No.EL/3.2.10/Gen/J-6

**MODIFICATION SHEET NO. RDSO/WAM4/156**

**MODIFICATION FOR BBC MAKE DI TYPE QLM RELAYS**

1 1					
						A 4	0	1	1
BBC	From	Relay type DI – Locking of the armature			HBTA 8659

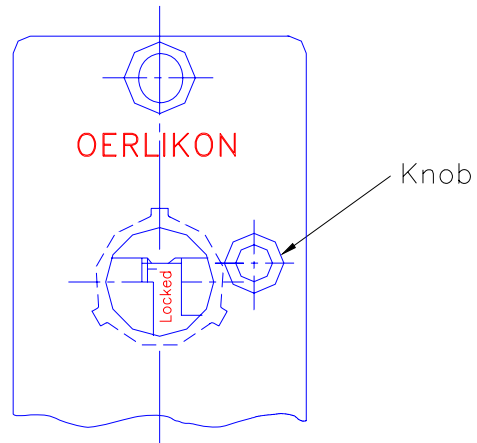
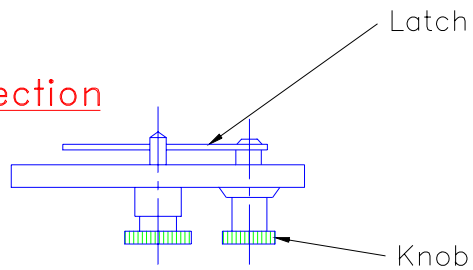
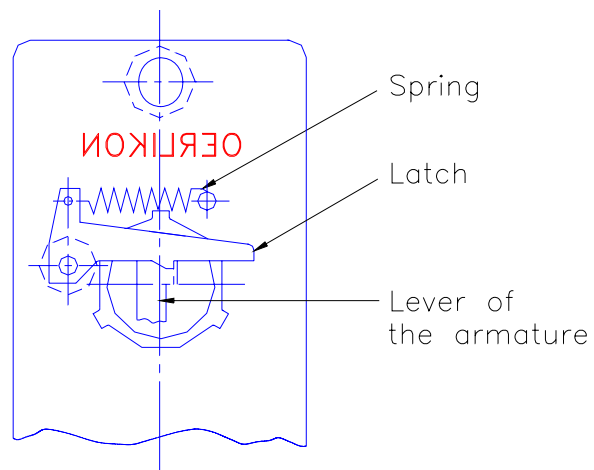
**1.5** The large number of auto reset type QLM relays already in service shall be modified by providing a different type of latching arrangement as per the details given below:

- 2.1** See BBC Drg. No. HBTA 8659 Relay type DI-Locking of the Armature.
- 2.2** Procure latching arrangement KA 220094 according to BBC Drg. No. HBTA 8659 as per the requirement. Remove the old one and replace with the new arrangement. One sample relay No. HB 547548 with modified latching arrangement is available in GZB Elect. loco shed in which actual fitment of component may be studied if required.

- 2.4** Copy of the BBC offer BVW-E/7130 and indicating the prices in swiss francs for locking arrangement depending on the quantity ordered is enclosed for your reference. Railway may also explore the possibility of indigenous development of the modified latch mechanism. This arrangement is interchangeable with the present flag mechanism and may be replaced easily by removing old latching and fixing the new one at the same mounting location.

- Locking arrangement for relays type DI QLM-application KA 220094 according to BBC Drg. No. HBTA 8659.
- Quantity will be as per the sheds require.

- Complete flag mechanism (old.)
